# HISTORIC AND DESIGN REVIEW COMMISSION

August 07, 2019

**HDRC CASE NO:** 2019-414  
**ADDRESS:** 367 QUENTIN DR  
**LEGAL DESCRIPTION:** NCB 8411 BLK 6 LOT E 25 FT OF 6 & W 35 FT OF 7  
**ZONING:** R-6,H  
**CITY COUNCIL DIST.:** 7  
**DISTRICT:** Monticello Park Historic District  
**APPLICANT:** JEFF CHOI/WINDOW EXPO  
**OWNER:** ROBERTO FLORES/VELASQUEZ LISA MARIE  
**TYPE OF WORK:** Window and door replacement  
**APPLICATION RECEIVED:** July 16, 2019  
**60-DAY REVIEW:** September 14, 2019  
**CASE MANAGER:** Adam Rajper  
**REQUEST:**

1. Replace thirteen (13) windows
2. Replace two doors (front and rear)

FRONT

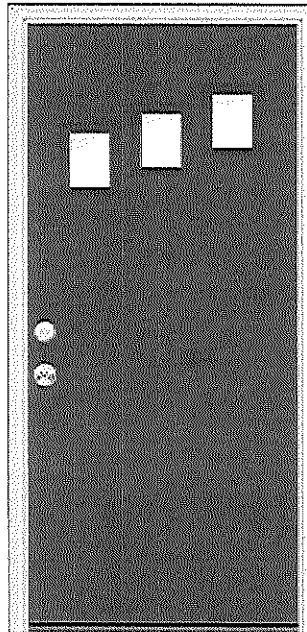
- c. **DOOR REPLACEMENTS** – The applicant has proposed to replace two doors (front and rear). According to the Historic Design Guidelines for Exterior Maintenance and Alterations, replacement doors should be appropriate for the style of the home. Staff finds that the proposed doors are appropriate for the Mid-Century Modern style of the home.

Item 2, Staff recommends approval of the door replacements based on finding c.
